## Product Change Notification / SYST-22OZTS834

ERRATA - dsPIC33EPXXXGP50X, dsPIC33EPXXXMC20X/50X, and PIC24EPXXXGP/MC20X Family Silicon Errata and Data Sheet Clarification

**Description of Change:** Updated silicon issue 30.

## dsPIC33EPXXXGP50X, dsPIC33EPXXXMC20X/50X and PIC24EPXXXGP/MC20X Family Silicon Errata and Data Sheet Clarification

**FIGURE 1: TIMING DIAGRAMS FOR CENTER-ALIGNED AND EDGE-ALIGNED MODES**

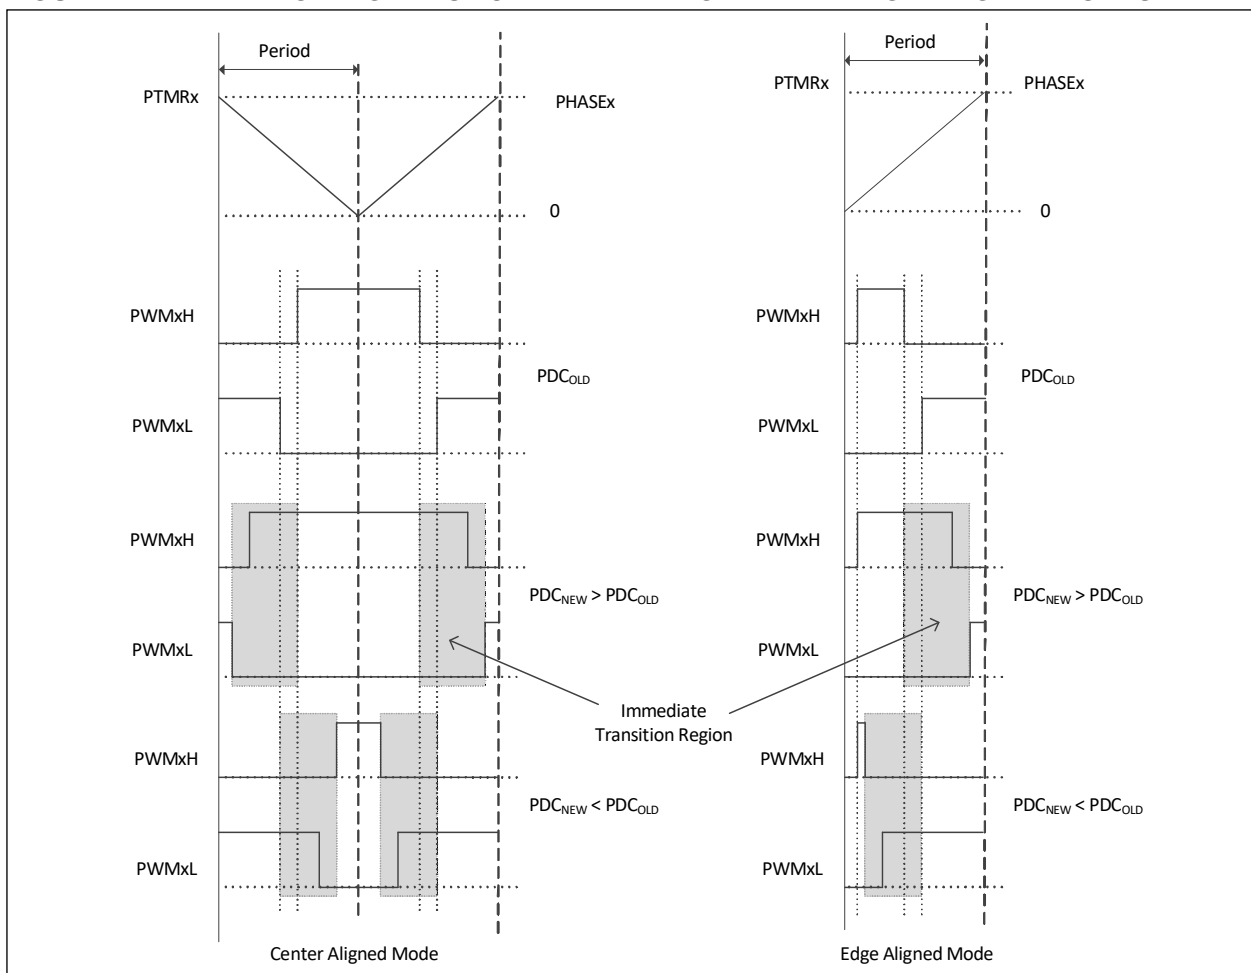
time base, will determine if the PWMxH and PWMxL outputs make an immediate transition. PWMxH and PWMxL outputs make an immediate transition if the Duty Cycle register is written with a new value, PDC<sub>NEW</sub>, at a point of time when the PWM time base is counting a value that is between PDC<sub>NEW</sub> and PDC<sub>OLD</sub>. Additionally, writing to the Duty Cycle register, close to the instant of time where dead time is being applied, may result in a reduced dead time effective on the PWMxH and PWMxL transition edges.

In [Figure 1](#), if the duty cycle write occurred in the shaded box, then PWMxH and PWMxL will make an immediate transition without dead time.

**FIGURE 2: PWM TIMING DIAGRAM**

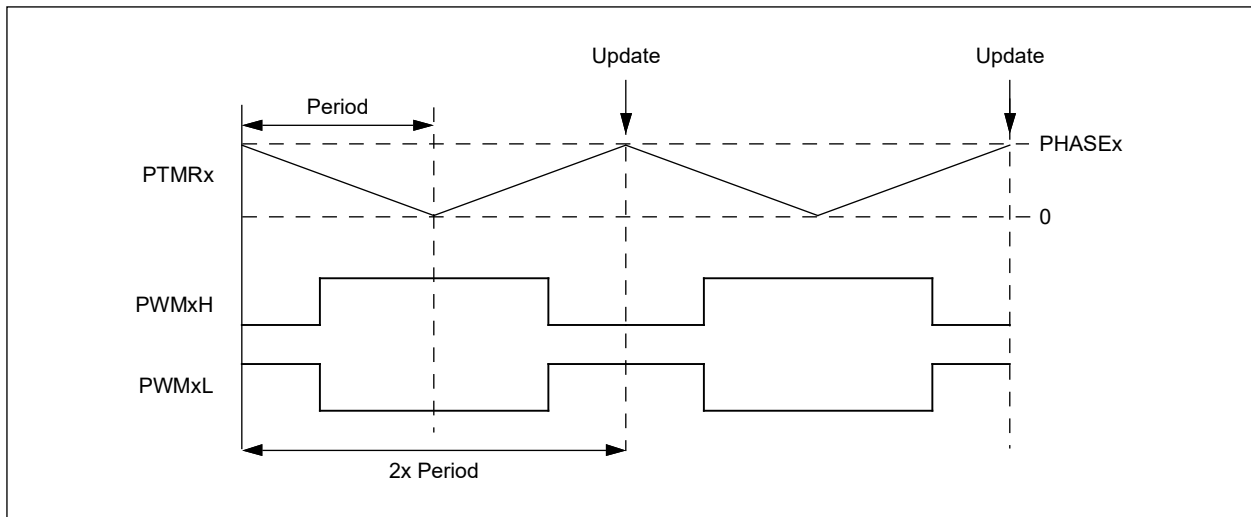
In Center-Aligned mode, updates to active MDC/PDCx/ALTDTRx/PHASEx registers occur only once every two PWM periods; that is, when the PWM timer matches the PHASEx register. In other words, the double update feature is not available. Figure 2 illustrates this relationship.

**FIGURE 3: CORRECT AND INCORRECT POSITION COUNT CAPTURES**

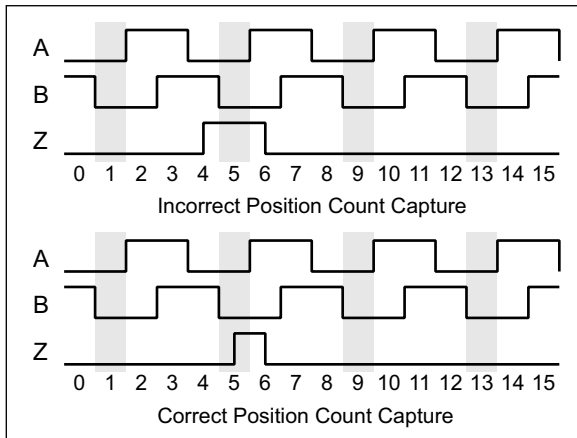
When index count position capture is being used (QEIXIOC.QCAPEN = 1), the position count may be one more or one less than the correct value, depending on the direction of the count.

This is only observed when the leading edge of the index pulse occurs prior to the leading edge of the index match event. When the index pulse starts after the leading edge of the index match event, the position count is captured correctly.

Figure 3 shows how this occurs. In these cases, Encoder Signals A, B and (index) Z are shown, with the module being configured for index match when A and B are '0'. The effects of a correct and incorrect capture are shown side by side (shaded areas indicate the index match event); the position count is shown along the bottom.

For encoder signals with timing that ensures the index pulse always starts prior to the start of the index match event (i.e., encoders with a non-gated index pulse), measure the direction of the encoder motion. If the encoder is counting up, add one to the captured position count; if the encoder is counting down, subtract one from the captured position count.

For encoder signals where the index pulse leading edge approximately coincides with the start of the index match event (i.e., encoders with a gated index pulse), a small delay can be added to the index pulse, for instance, by using a simple R-C filter.

FIGURE 4: PWM GENERATOR TIMING DIAGRAM

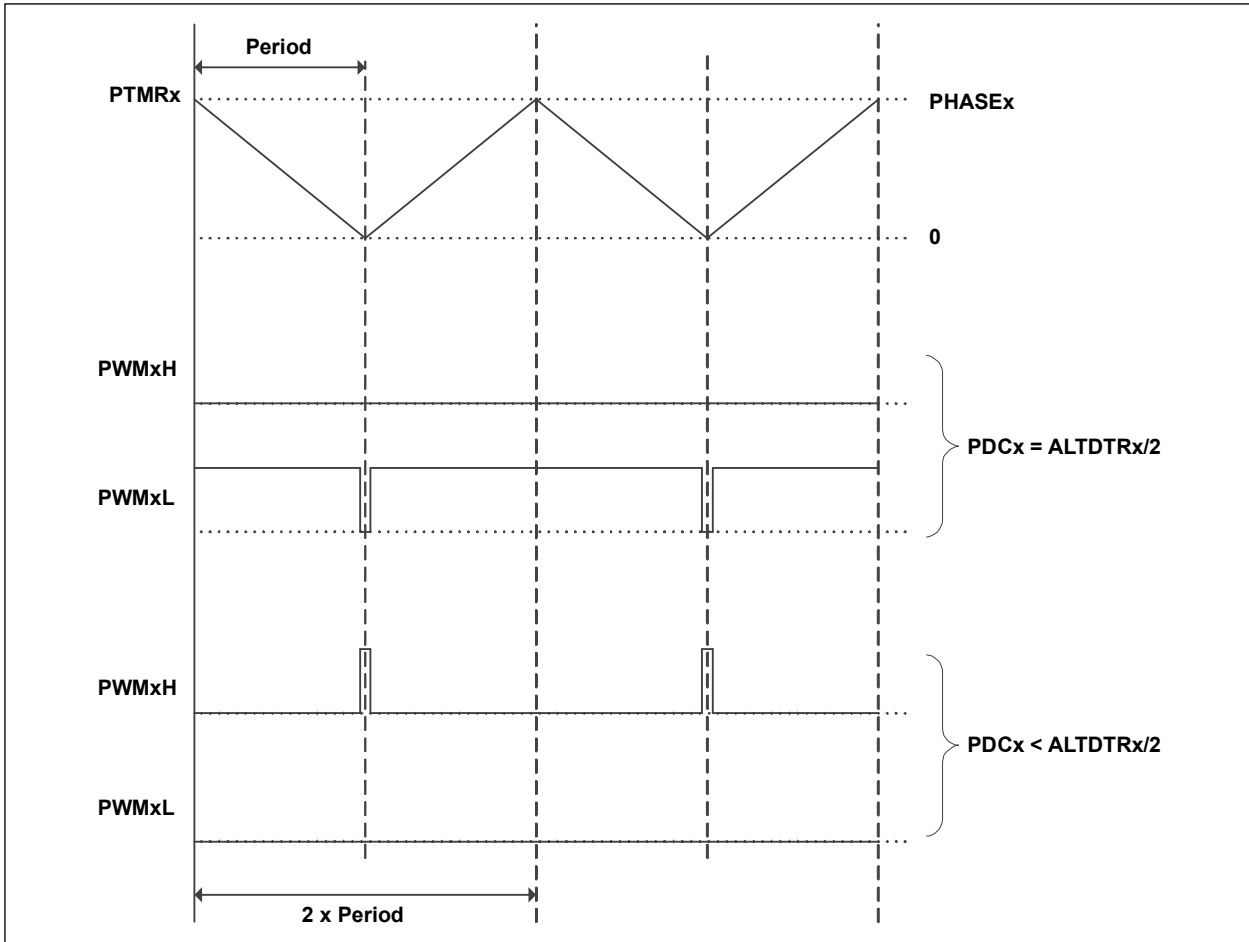
In Center-Aligned Complementary mode with Independent Time Base, if the value in the PDCx register is less than one-half the value in the ALTDTRx register, the PWM generator will force the PWMxL to low, and on the PWMxH, generate pulses of width less than twice the dead time, as shown in Figure 4.

**FIGURE 5: ILLUSTRATION OF 1 T<sub>osc</sub> GLITCH WHEN PWM OVERRIDE IS TURNED OFF**

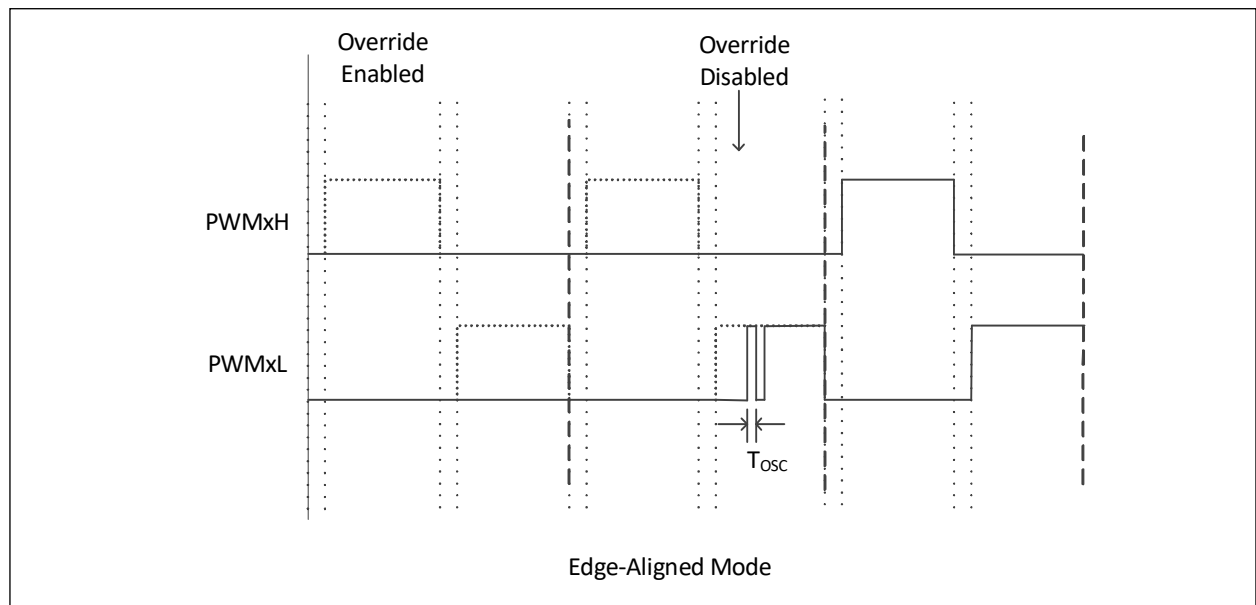
In Complementary mode after the PWMx module is enabled (PTEN = 1), if the PWM override is turned off, a 1 T<sub>osc</sub> glitch will be present on the rising edge of either PWMxH or PWMxL, whichever occurs first, as shown in Figure 5. The glitch will be present on PWMxH/PWMxL every time the override state is changed from enabled to disabled. The width of this glitch is equal to 1 T<sub>osc</sub> when PCLKDIV[2:0] = 000; increasing the PWM input clock prescaler setting will increase the width of the glitch accordingly.

**FIGURE 6:**

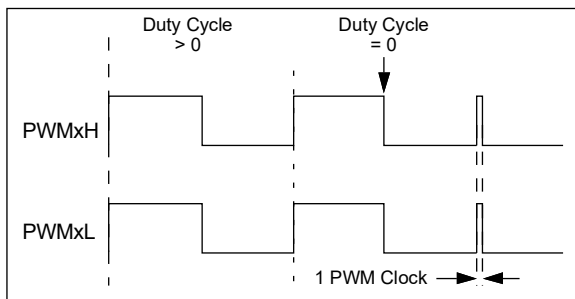
In certain output modes, the PWMx module produces a pulse glitch of one PWM clock in width (Figure 6). This has been observed only when all of the following are true:

- Either Redundant or Push-Pull Output mode is selected (IOCONx[11:10] = 10 or 01);
- Immediate Update is disabled (PWMCONx[0] = 0); and
- The value of the current Duty Cycle register (either the PDCx or MDC register, as determined by PWMCONx[8]) is updated to zero from any non-zero value.

The pulse glitch has been observed to occur at the beginning of the following PWM boundary period.

**FIGURE 7:**

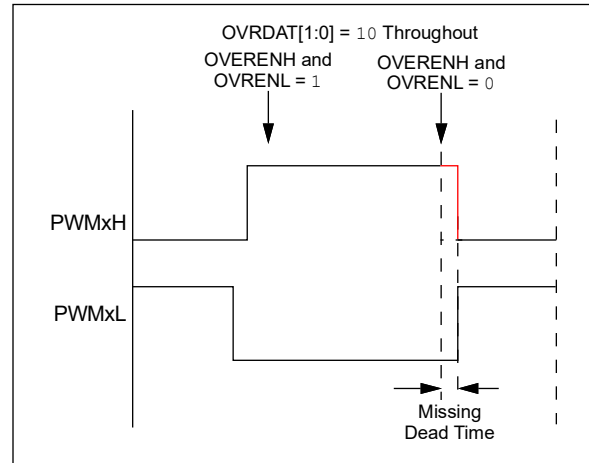
- Output override synchronization is configured to occur on the CPU clock boundary (IOCONx[0] = 0);
- Both PWMxH and PWMxL overrides are enabled prior to the event (OVRENH and OVRENL are both '1'), and
- Both overrides are disabled (OVRENH and OVRENL are both '0') at the instant the dead time should be asserted (Figure 7).

This has been observed in both Center-Aligned and Edge-Aligned modes.

**FIGURE 8:**

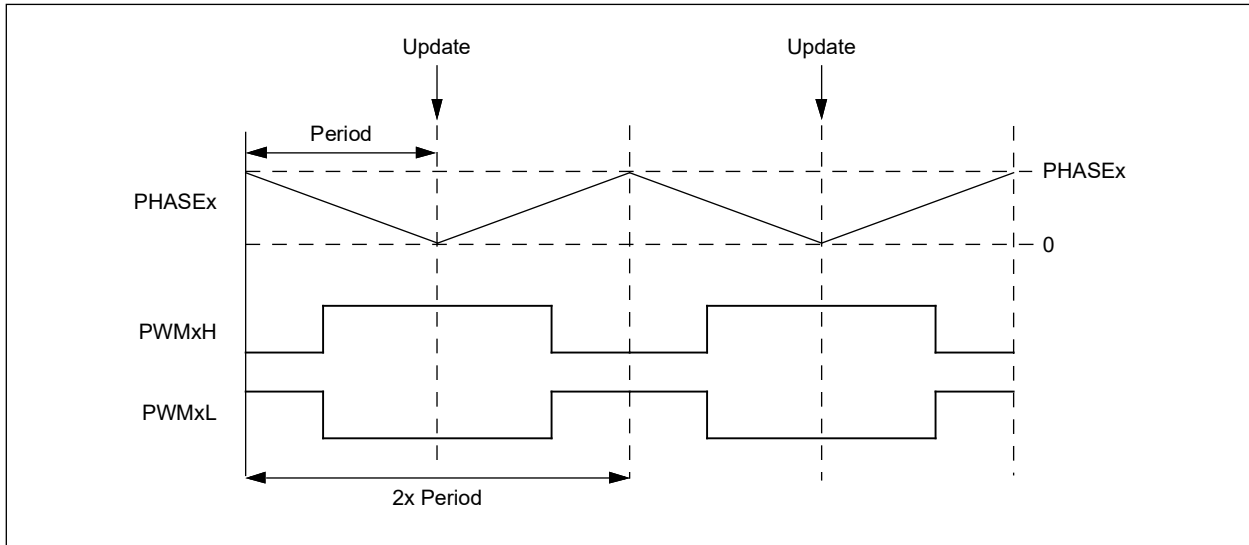
In Center-Aligned Complementary mode with Independent Time Base, updates to the PHASEx register take effect in the middle of a center-aligned PWM cycle, as shown in Figure 8. This occurs only when the Immediate Update feature is disabled (IUE = 0). If Immediate Update is enabled (IUE = 1), the PHASEx register updates will take effect immediately.

**FIGURE 9: SIMPLIFIED BEHAVIOR**

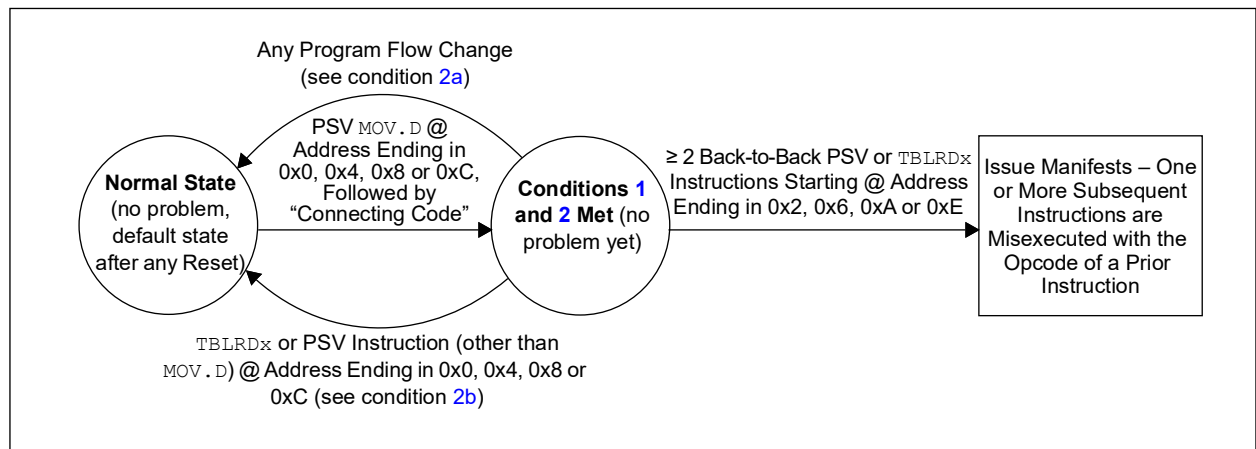
| 3. | $\geq 2$ back-to-back PSV or <code>TBLRDx</code> instructions are executed (following the code of condition 2), where the first of the back-to-back instructions is located at an address ending in 0x2, 0x6, 0xA or 0xE.   |

Figure 9 provides an example of the effective behavior.

1. All instances of PSV `MOV.D` can be replaced with two PSV `MOV` instructions instead. Non-PSV `MOV.D` instructions acting on RAM/SFRs do not need to be modified; or
2. If not already present, a program flow change instruction (such as `BRA $+2`) can be inserted above back-to-back data Flash read sequences; or
3. Back-to-back data Flash read instruction sequences can be broken up by inserting a non-Flash read instruction (such as a `NOB`) in between the Flash read instructions; or
4. The alignment of the code can be shifted to avoid the required opcode location addresses.

C code built with MPLAB® XC16 Compiler, Version 1.32, or later, implements the work around by default. However, if the application uses Assembly language routines, these should be manually modified to implement the work around. Additionally, if precompiled libraries are used, these should be built with XC16 Version 1.32 or later. For additional information, please visit: [www.microchip.com/erratum\\_psrds\\_psrds](http://www.microchip.com/erratum_psrds_psrds).
